# HISTORIC AND DESIGN REVIEW COMMISSION

September 06, 2023

**HDRC CASE NO:** 2023-341  
**ADDRESS:** 211 WICKES  
**LEGAL DESCRIPTION:** NCB 938 BLK 1 LOT 4  
**ZONING:** RM-4, H  
**CITY COUNCIL DIST.:** 1  
**DISTRICT:** King William Historic District  
**APPLICANT:** Elaine Lutton/Lutton Properties LLC  
**OWNER:** LUTTON PROPERTIES LLC  
**TYPE OF WORK:** Construction of a rear addition  
**APPLICATION RECEIVED:** July 13, 2023  
**60-DAY REVIEW:** September 11, 2023  
**CASE MANAGER:** Claudia Espinosa

The applicant is requesting a Certificate of Appropriateness for approval to construct a 653-square-foot rear addition

REAR ELEVATION

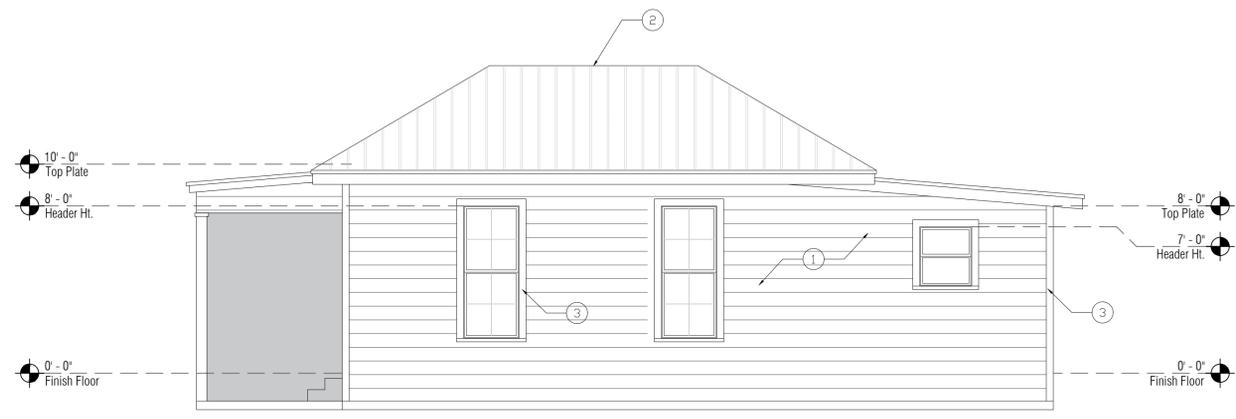
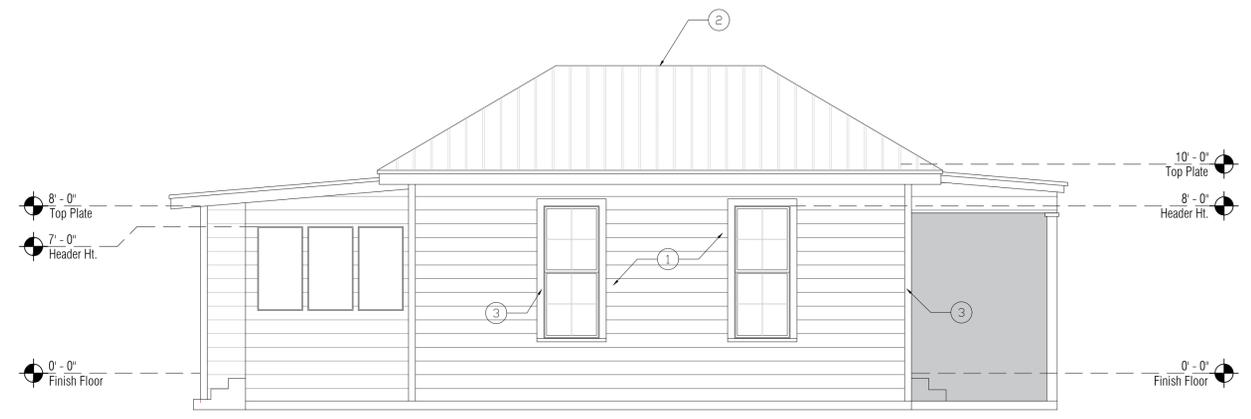
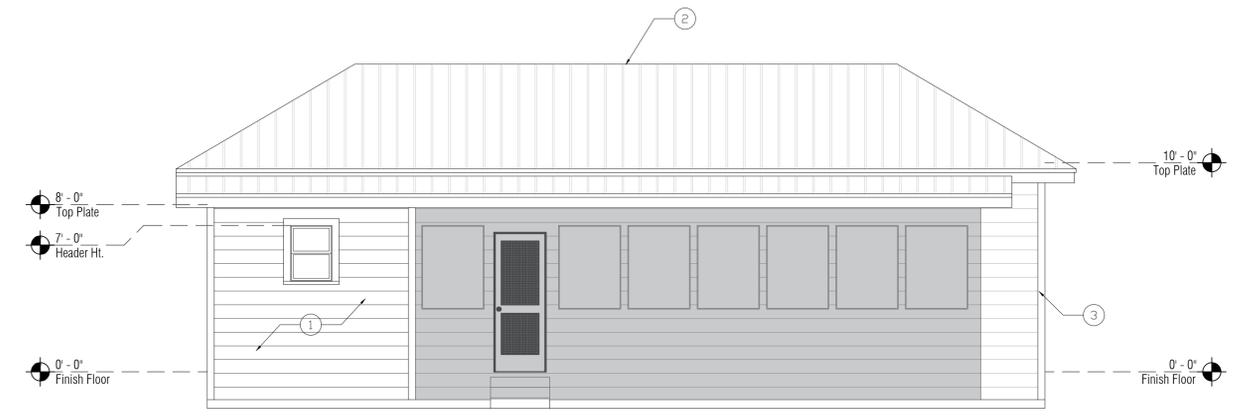
- k. **ADDITION: ARCHITECTURAL DETAILS** – The applicant has proposed to construct a rear addition. Guideline 4.A.ii for Additions states that additions should incorporate architectural details that are in keeping with the architectural style of the original structure. Details should be simple in design and compliment the character of the original structure. Architectural details that are more ornate or elaborate than those found on the original structure should not be used to avoid drawing undue attention to the addition. The applicant has proposed fascia that is not symmetrical to the structure on the rear addition. Staff finds the applicant should

explore a hip roof and align the fascia on the rear addition consistent with the primary structure to provide symmetry to the structure.

- ii. That the applicant modifies the roof form to a form that is more complementary to the structure based on finding d and k, and that the applicant submits updated elevation drawings to staff for review and approval prior to the issuance of a Certificate of Appropriateness.

- iv. That the applicant explore a hip roof and align the fascia on the rear addition consistent with the primary structure to provide symmetry to the structure.
